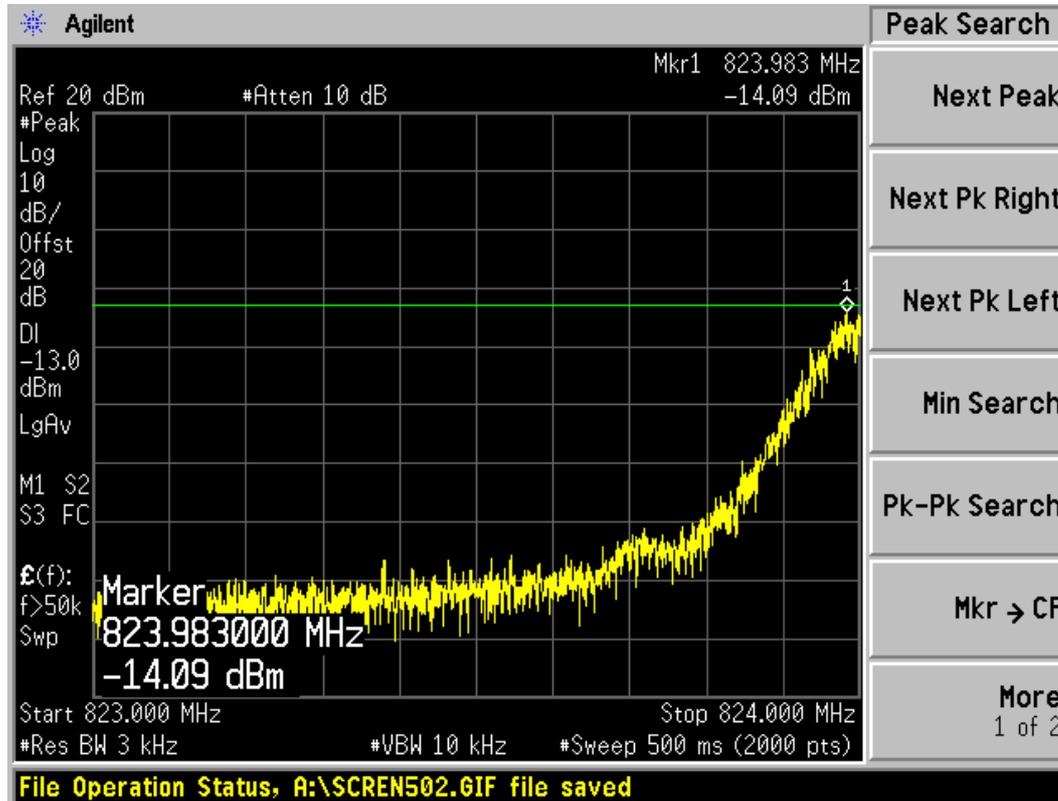
4) It appears that power via the substitution method was performed in an anechoic chamber. However the current version of TIA/EIA 603-C only allows use of an OAT's or qualified semi-anechoic chamber. Please correct.

[Reply: We already change the test site to Semi-Anechoic chamber and update the report.](#)
